Subject: Sol-luce Kingston Solar PV Energy Project, NHA Modifications

Sol-luce Kingston Solar PV Energy Project

Figure 1: Project Location and New Lands

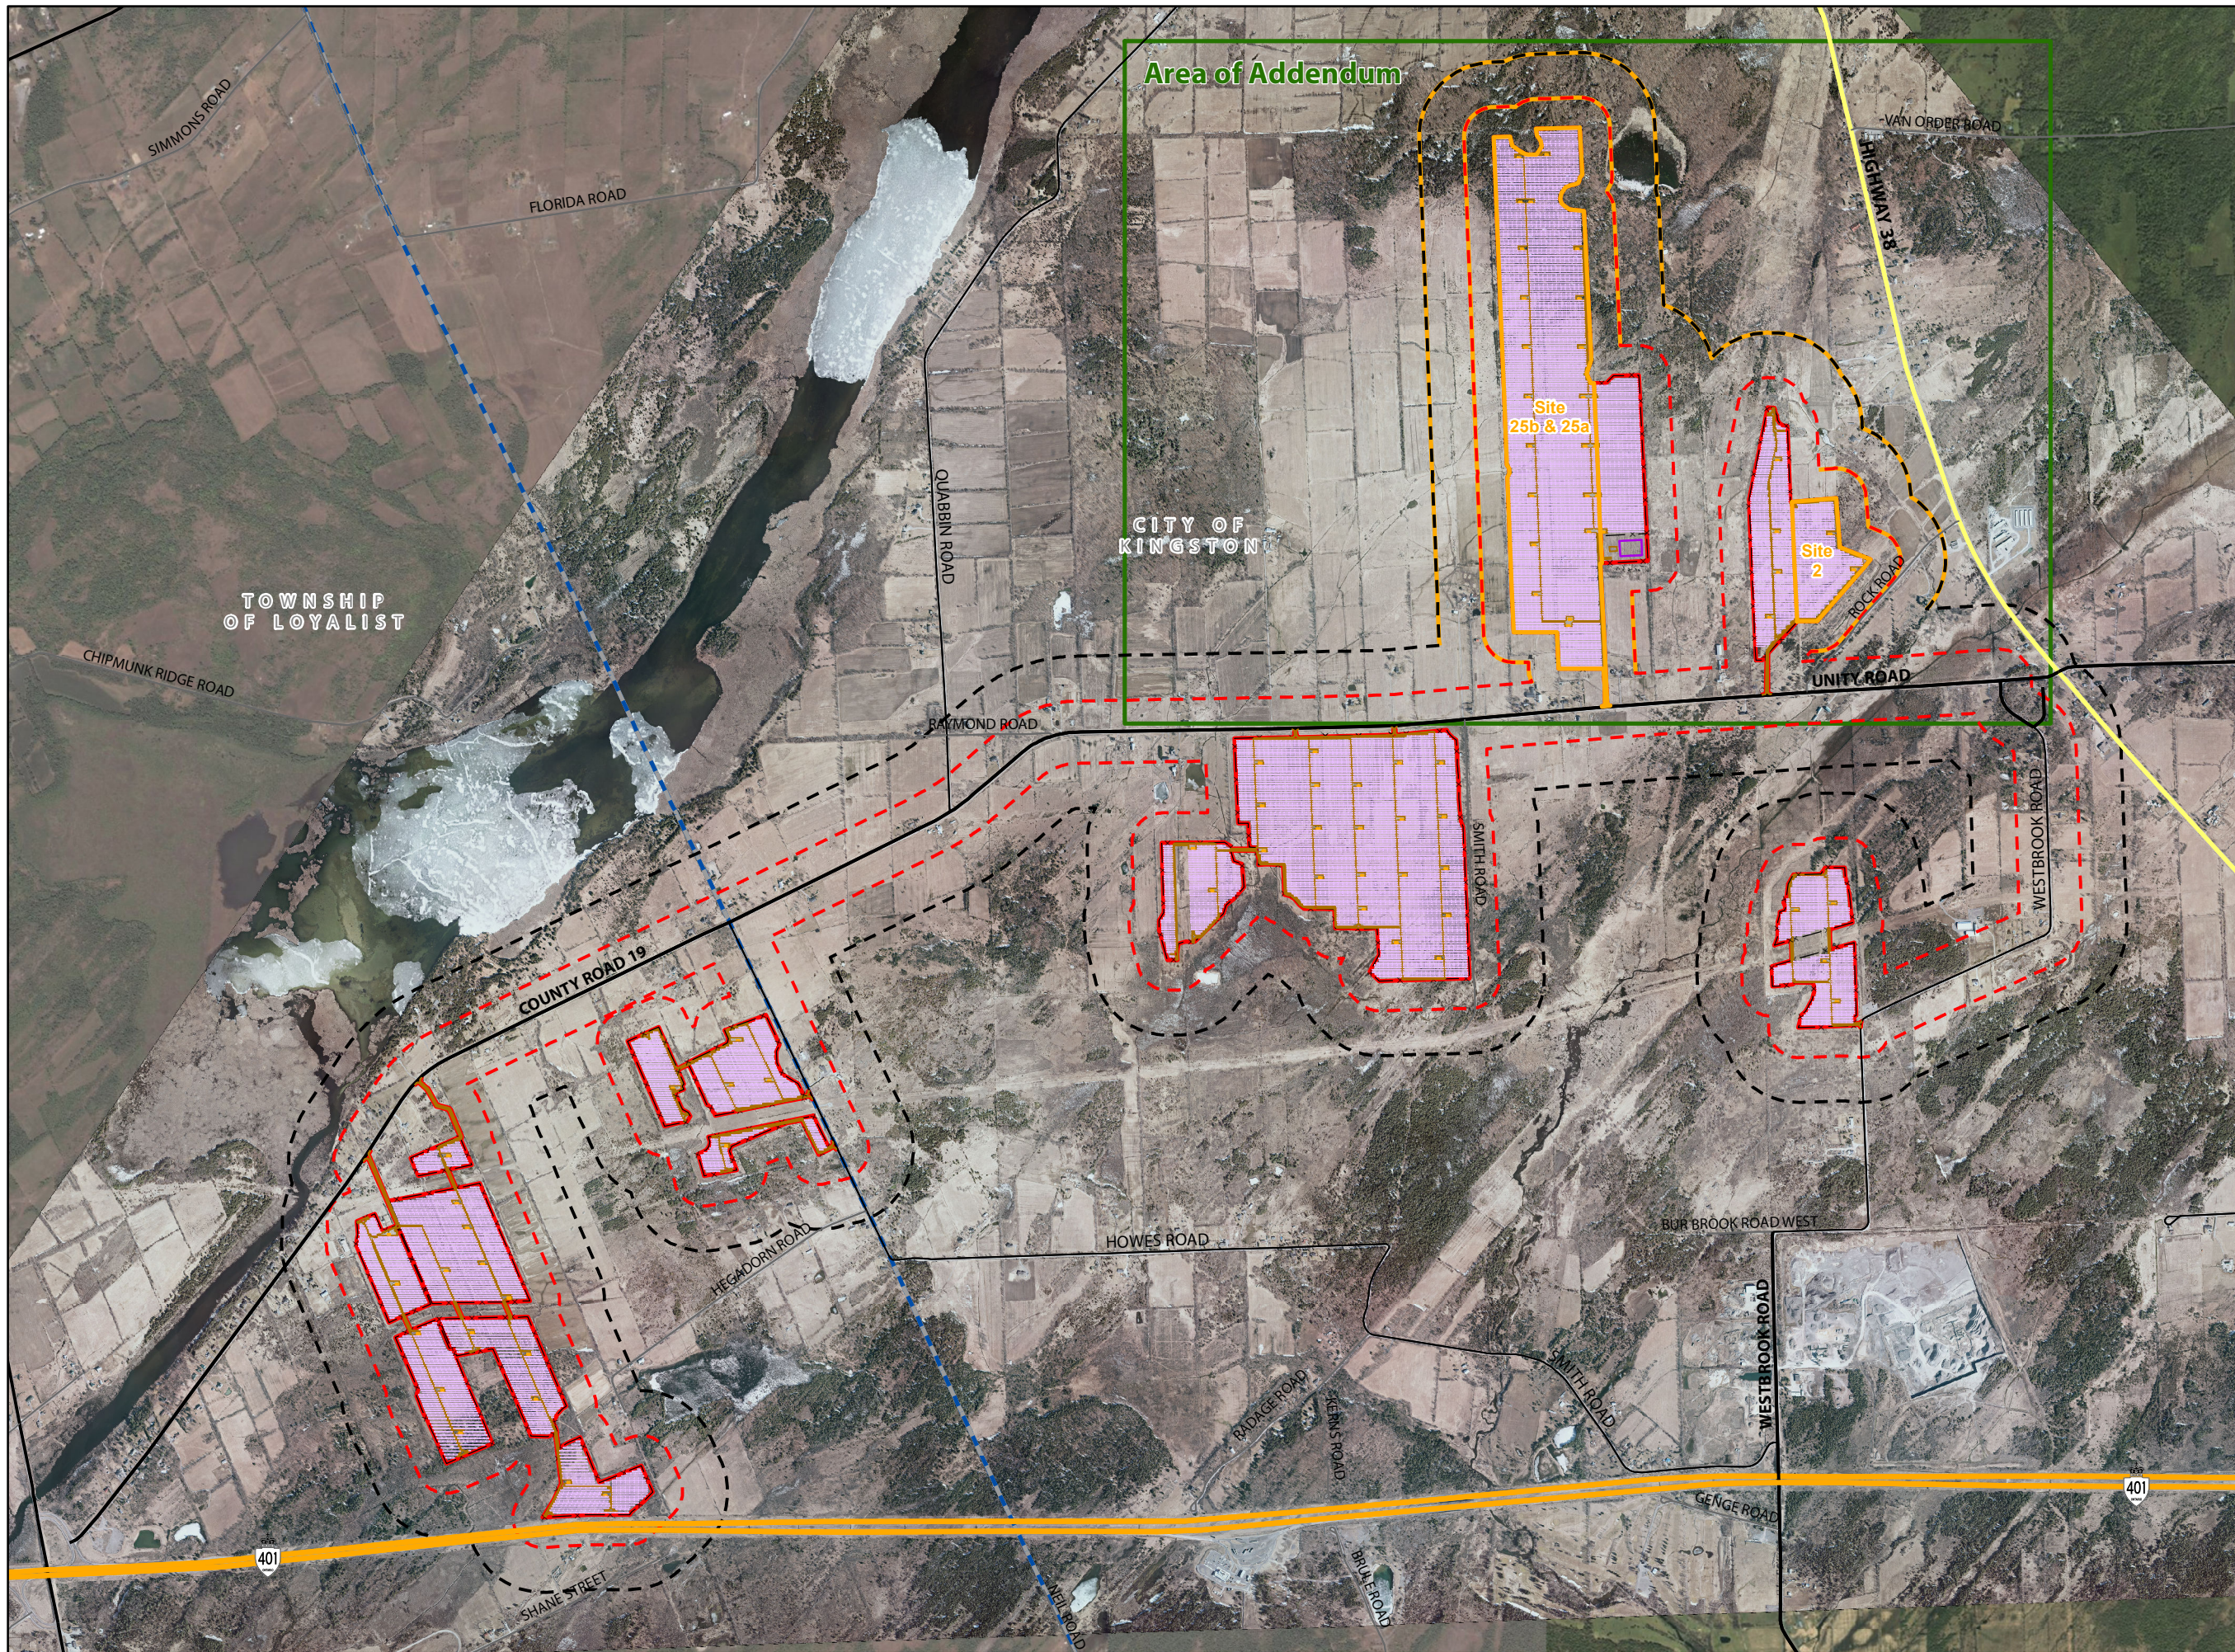
The NHA addendum reports identify and evaluate natural features associated with the addition of three properties: Properties 2, 25A, and 25B (i.e., the amended project location); however, they do not include discussion on the natural features associated with the removal of five properties that are no longer being considered for the solar project (Properties 1, 6A, 9, 10, and 11; see attached Figure 1 for properties added and removed; and Figure 2 for the amended Project Location). This NHA Modification

A NHA records review is meant to broadly describe the potential for natural features near a proposed development; therefore, few modifications are necessary. The following natural features are no longer applicable to the Sol-luce Kingston NHA reports (Section 2; AMEC 2012) due to the removal of Properties 1, 6A, 9, 10, and 11 and are thus no longer relevant:
